City of Seattle

DESIRABLE LOCATIONS FOR UTILITIES (RESIDENTIAL STREET)

HANDHOLES

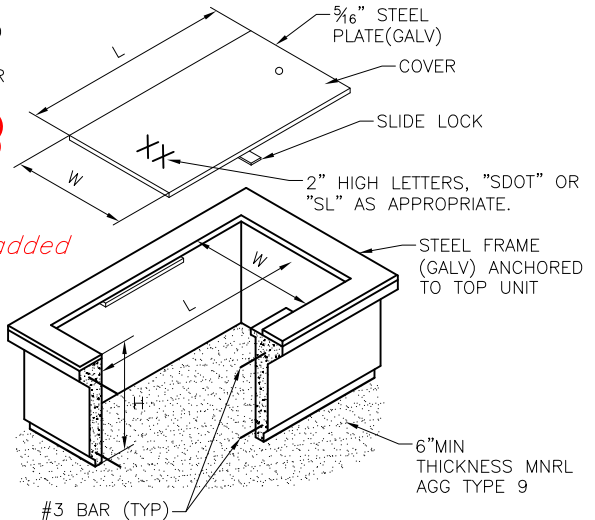
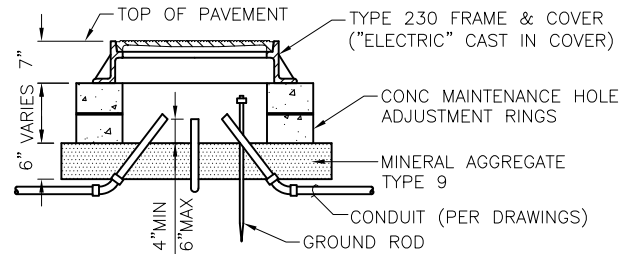
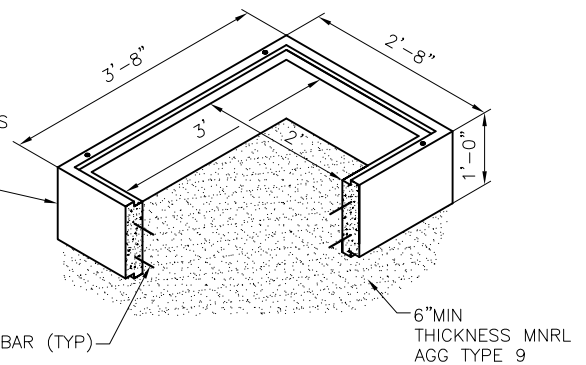
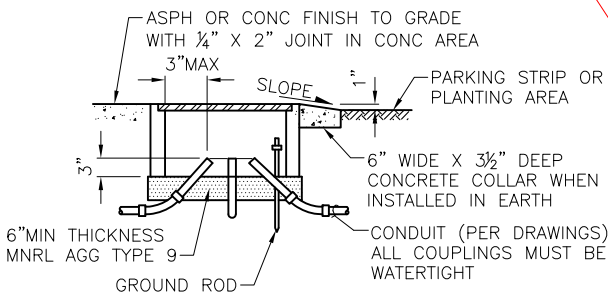
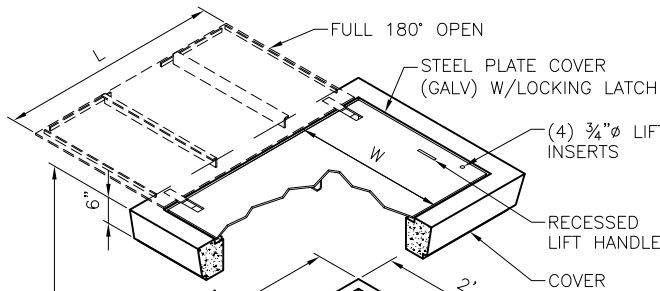
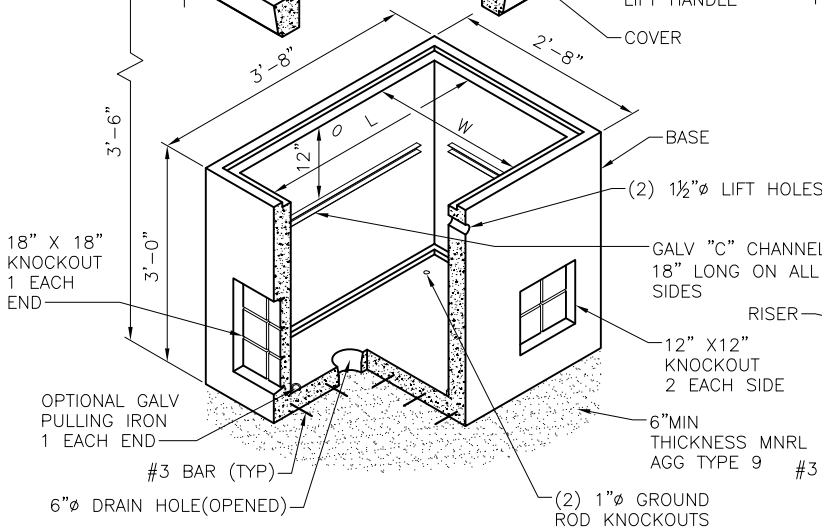
details added

RED BUS LANE MARKINGS

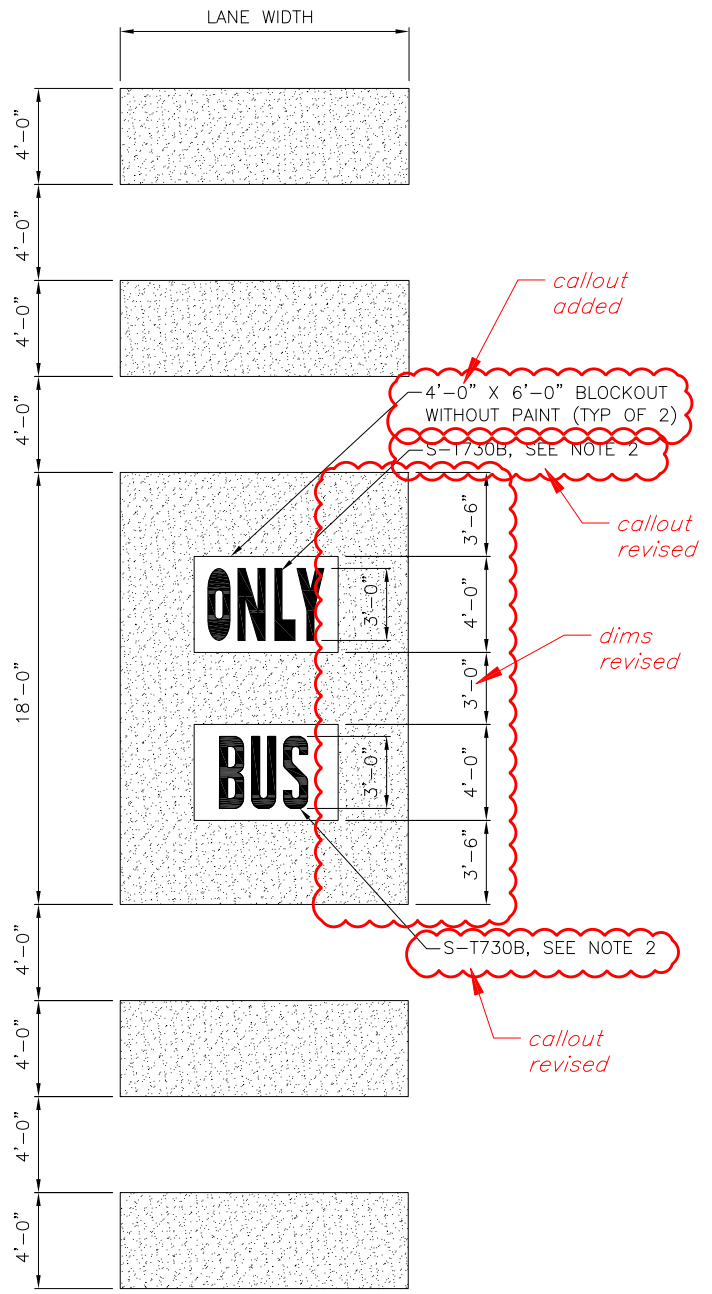
note 1 revised, note 2 added

1. FHWA APPROVED RED COLOR FOR BUS LANES MUST BE USED WITH MMA.
2. FOR APPLICATION ON CEM CONC PVMT, LEGENDS PER STANDARD PLAN 730 MUST HAVE A 5'-0" X 3'-0" COLOR BLACK THERMOPLASTIC BACKGROUND PER DETAIL A. FOR APPLICATION ON CEM CONC PVMT IN A STREET CAR TRACK, LEGENDS PER STANDARD PLAN 730 MUST HAVE A 4'-0" X 3'-0" COLOR BLACK THERMOPLASTIC BACKGROUND PER DETAIL B. PROVIDE 6" MINIMUM GAP BETWEEN THERMO LEGENDS AND RED MMA.
